### Staff Report & Recommendation

### Design Review Board

SUBJECT: DRB16-0106  
**1000 West Avenue – Mirador South**

The applicant, Mirador 1000 Condominium Association Inc, is requesting Design Review Approval for façade modifications of an existing sixteen-story building. Specifically, to replace existing concrete balcony railings on the south, west and north elevations of the building with glass railings or, in the alternative, a combination of glass and concrete railings.

**FLOOR PLAN (TYP)**

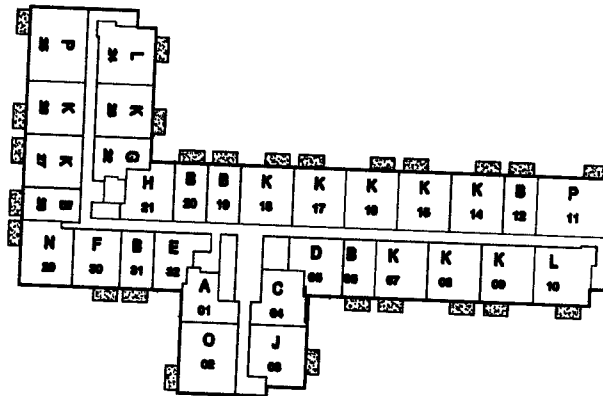
For Option 2, the applicant proposes a hybrid design for the balcony railings on the south and west, including the north elevation of the west wing. For these balconies, the long ends across from the entrances to the units will have all glass railings and the two ends will be approximately half cast-in-place concrete (adjacent to the building wall) and half glass. This alternative still affords views of the waterway and lightens the load on the balconies for structural integrity. In addition, since the south elevation may be viewed in passing from the City's right-of-way (West Avenue and 10<sup>th</sup> Street), the applicant will make the east ends of the south balconies fully cast-in-place concrete to maintain the appearance of the existing balconies as seen from the adjacent streets.

Staff is satisfied that the plans submitted for Option 2, a combination of glass and concrete railings, successfully address staff comments, and maintains the building's original aesthetic facing West Avenue and 10<sup>th</sup> Street. Further, staff believes that this Option is a fair compromise to address some Board members prior concerns. Staff recommends that the application be approved in accordance with this option.

- a. On the east elevations where the solid balconies act as framing elements to the central expanse of glazing, all glass railings shall not be permitted. Also the 13 balconies along the north and south elevation on the wing

closest to West Avenue on the south, all glass railings shall not be permitted on a total of 115 balconies.

- b. On the other non-West Avenue facing elevations, the plans submitted for Option 2, a combination of glass and concrete railings, shall be permitted as proposed.
